Proposed Updated Final Safety Analysis Report Tables and Figures
(Mark-Ups; for Information Only)
(164 pages follow)

FINAL PLANT LAYOUT, PLAN C ABOVE
ELEVS. 620'-6", 623'-6" AND
624'-6", PLANT COMPLEX
FIGURE 1.2-5
(DWG. E-013-0005-00000)

Figure 2.4-35

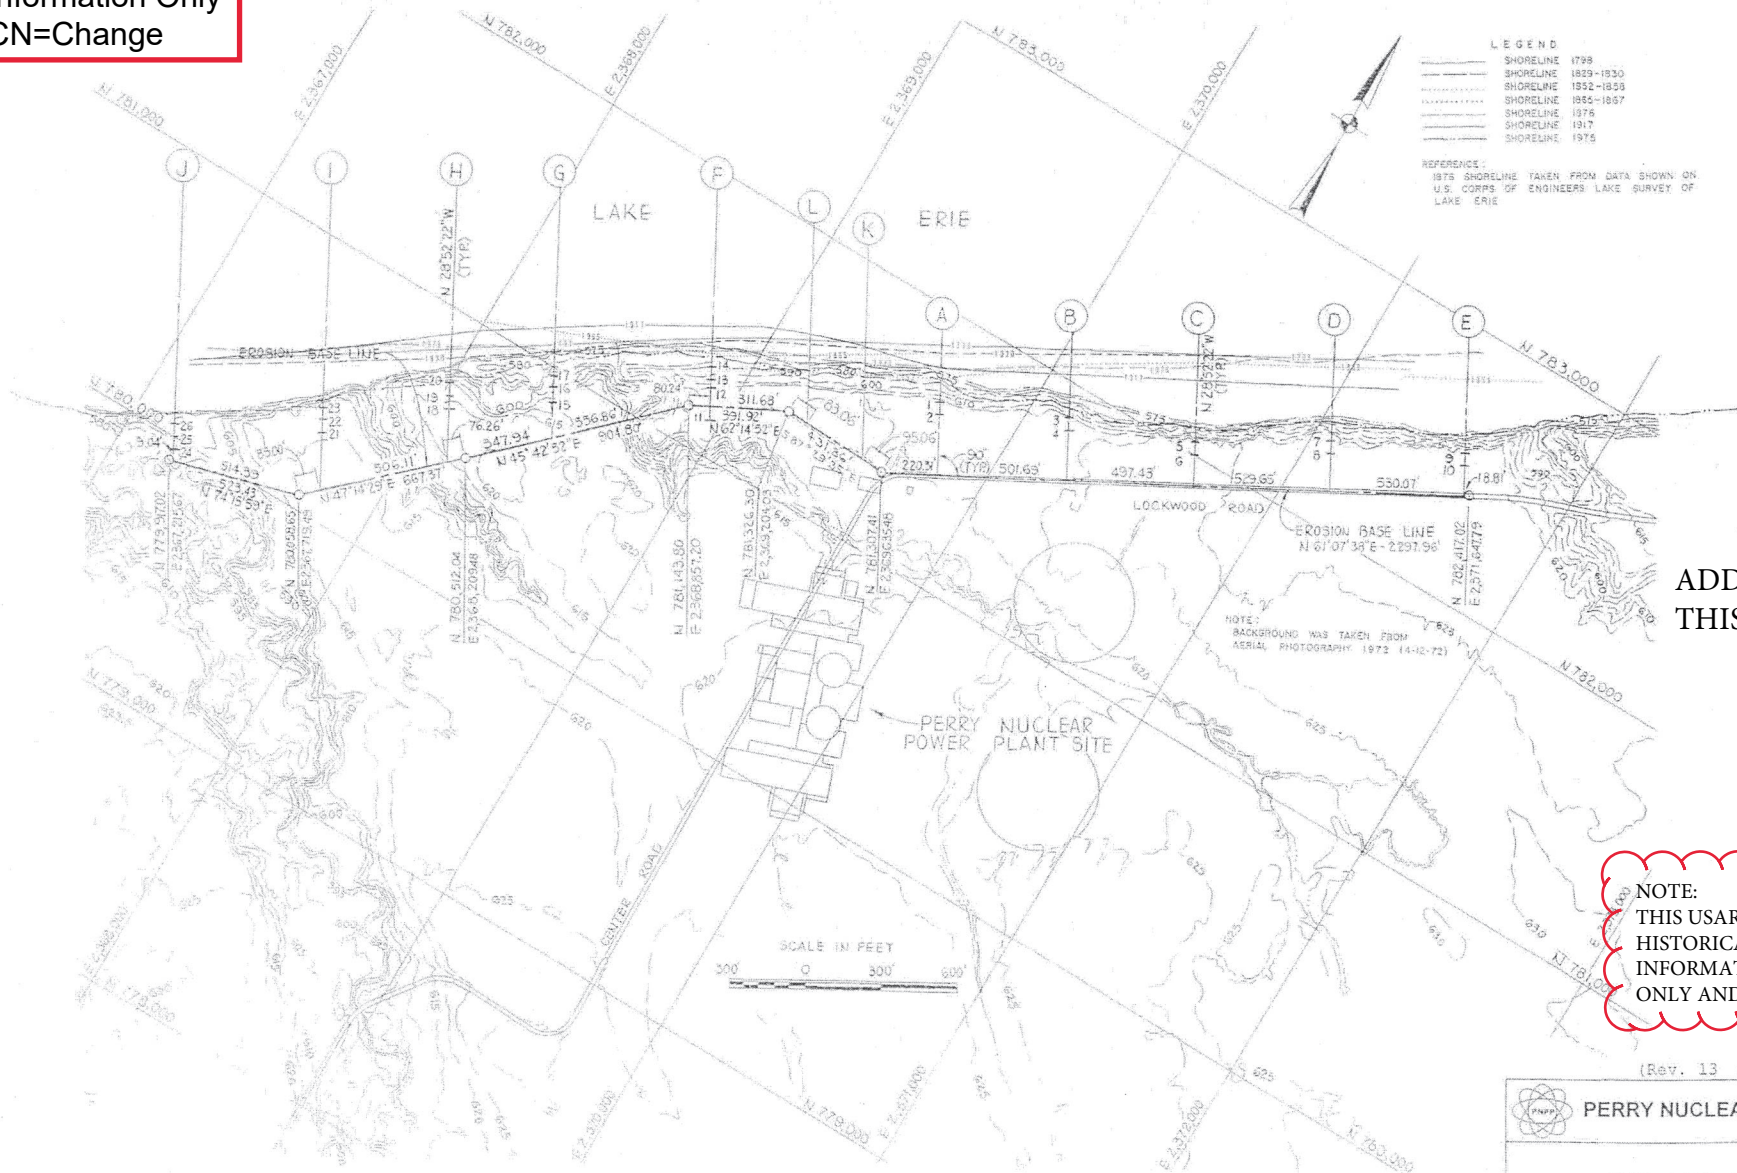
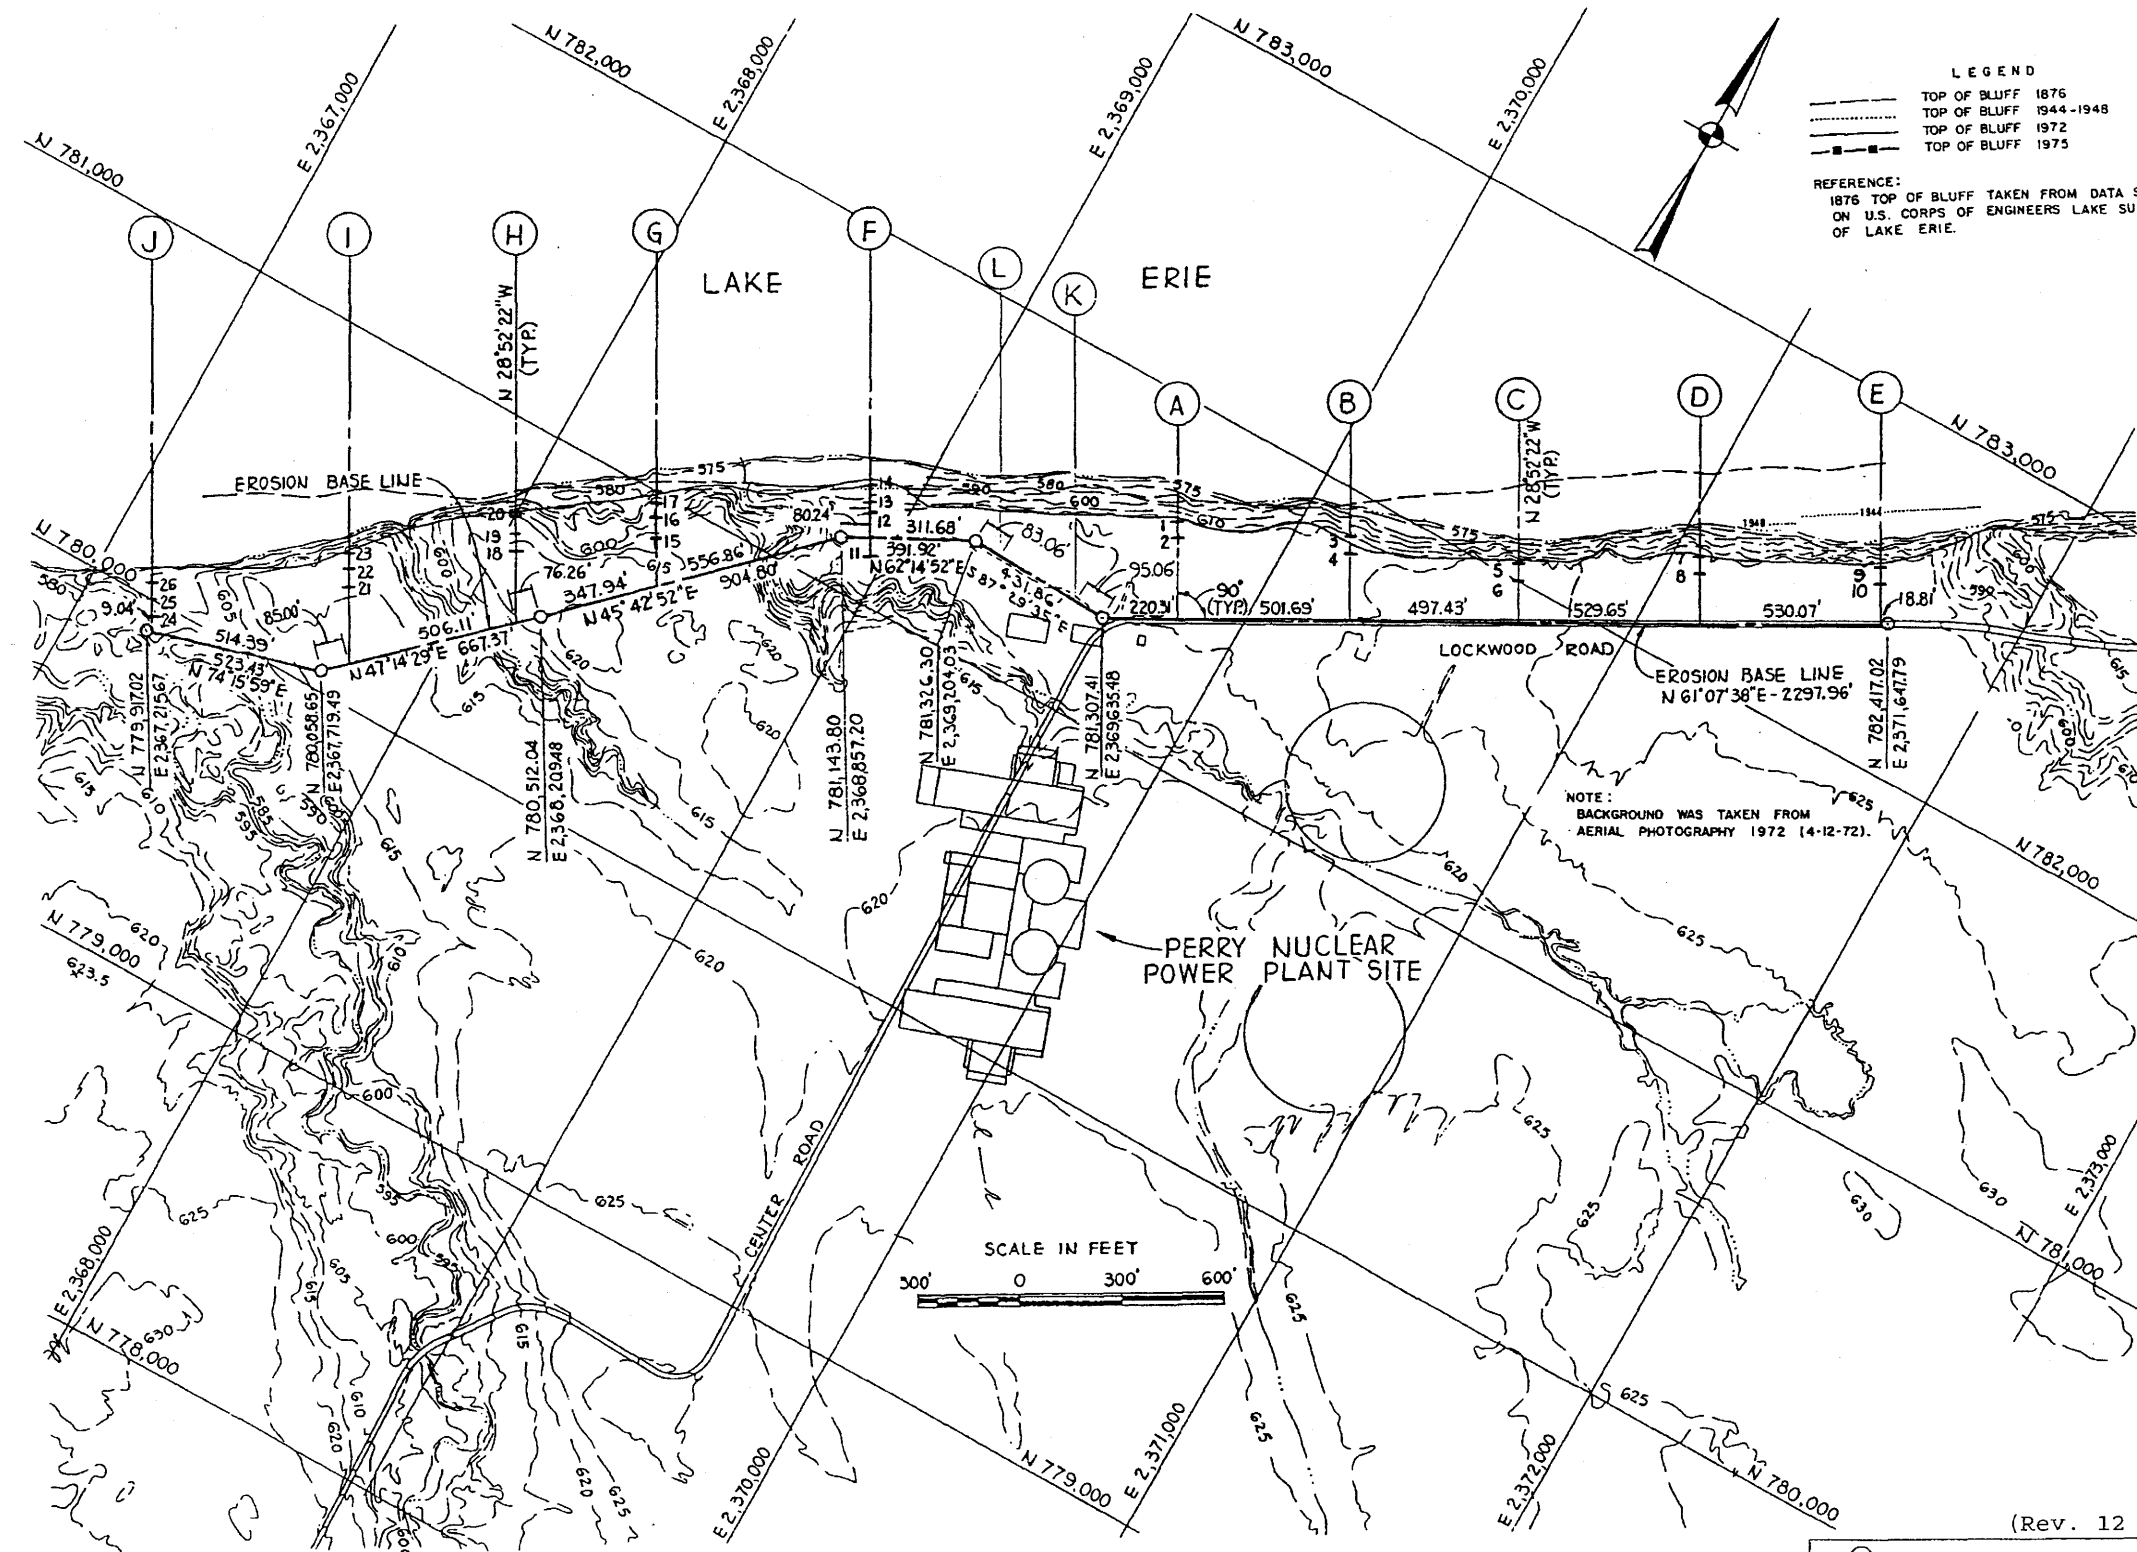
ADD NOTE
THIS CN

NOTE:
THIS USAR FIGURE CONTAINS
HISTORICAL TOPOGRAPHICAL
INFORMATION FOR REFERENCE
ONLY AND WILL NOT BE UPDATED.

PERRY NUCLEAR POWER PLANT
	1876 Top of Bluff
	Figure 2.4-36

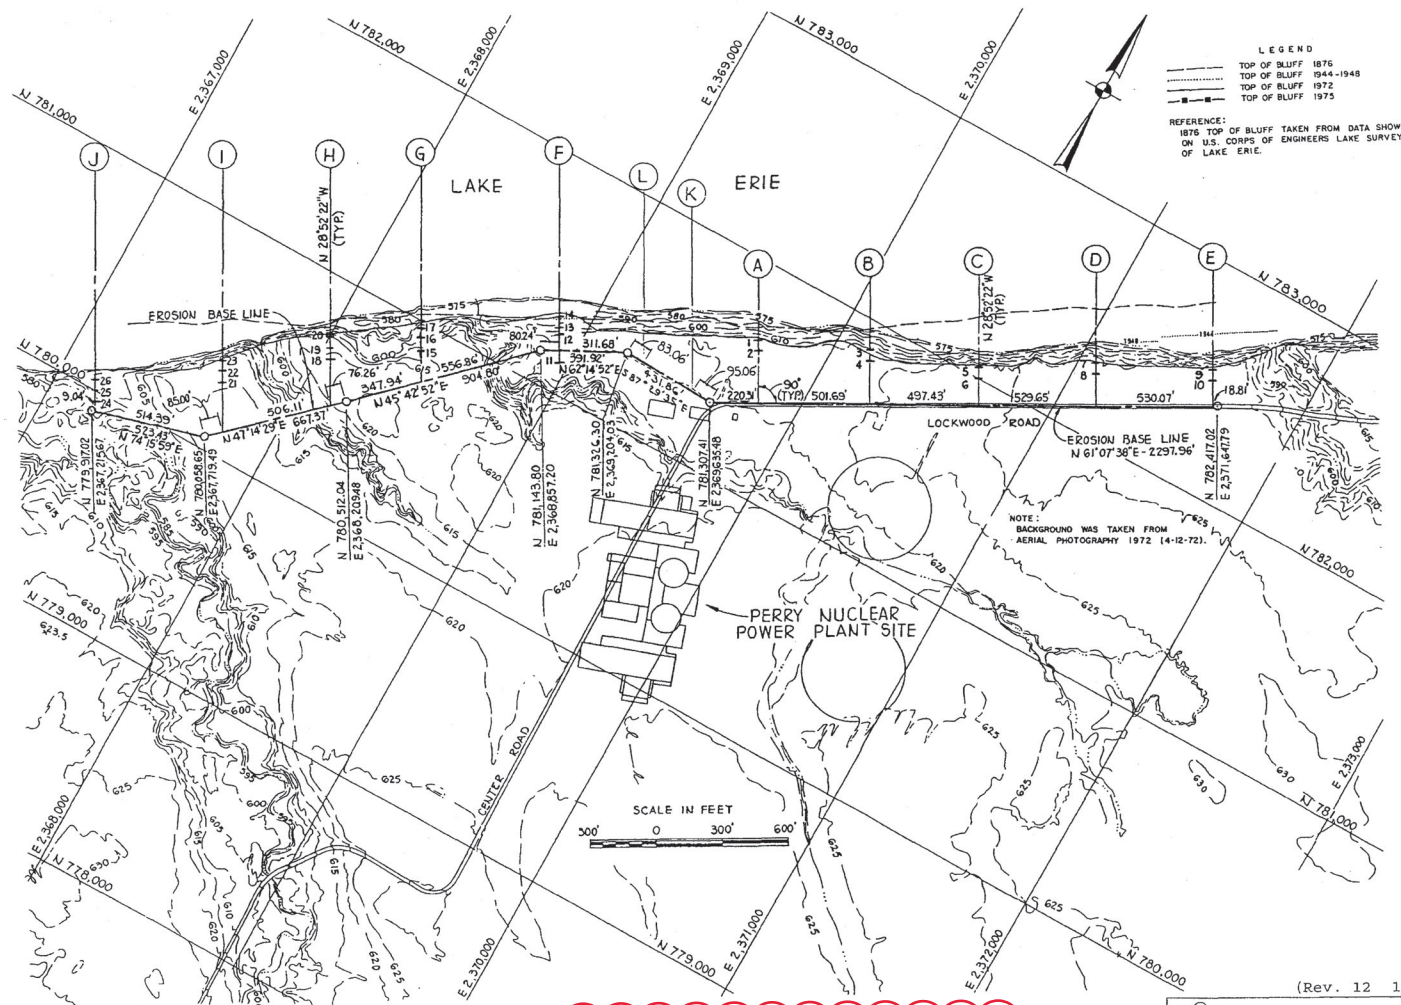
ADD NOTE
THIS CN

NOTE:
THIS USAR FIGURE CONTAINS
HISTORICAL TOPOGRAPHICAL
INFORMATION FOR REFERENCE
ONLY AND WILL NOT BE UPDATED.
